IFB 15-232-CP

Landfill Scale House Concrete Apron Replacement
Addendum No. 1

Landfill Scale House Concrete Apron Replacement
Contract No. SW-0801
IFB No. 15-232-CP

SKETCH SK-2

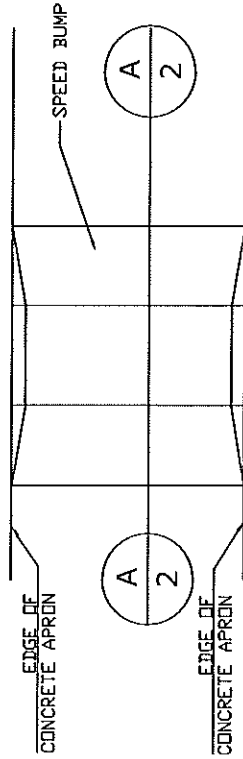
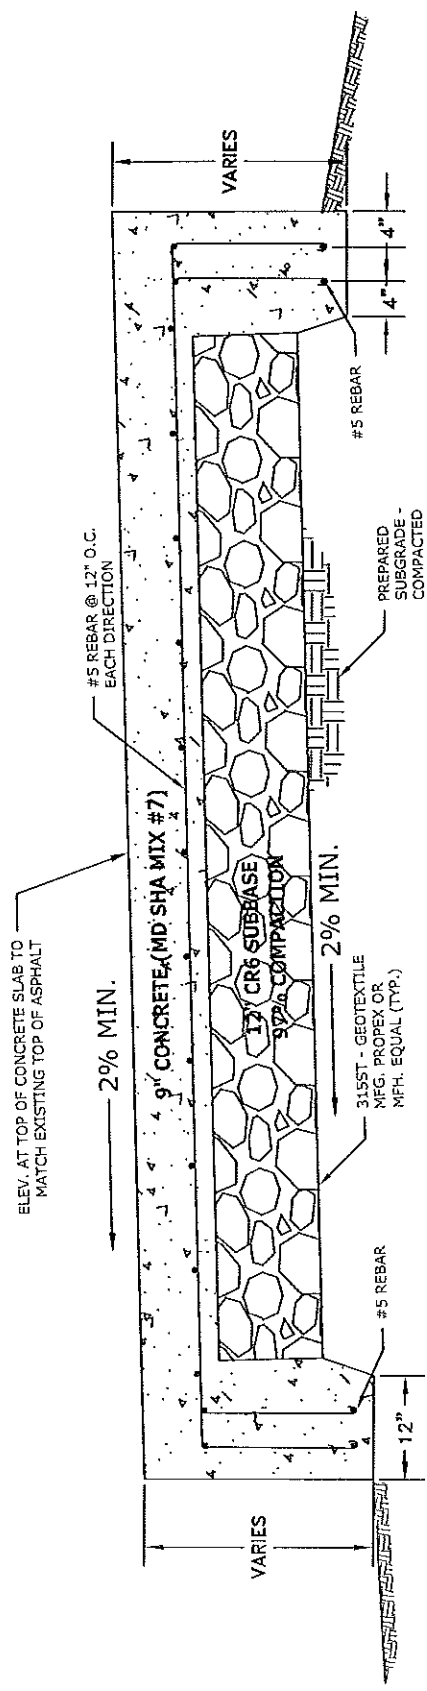
Question 4: Should a speed hump be installed on RFID lane?

Response 4: Yes, a speed hump should be installed to match the one that is currently in the field. Please see attached Sketch SK-2 for detail. Cost of the speed hump shall be included in the cost of Bid Item 2, Install 9" Concrete and Rebar.
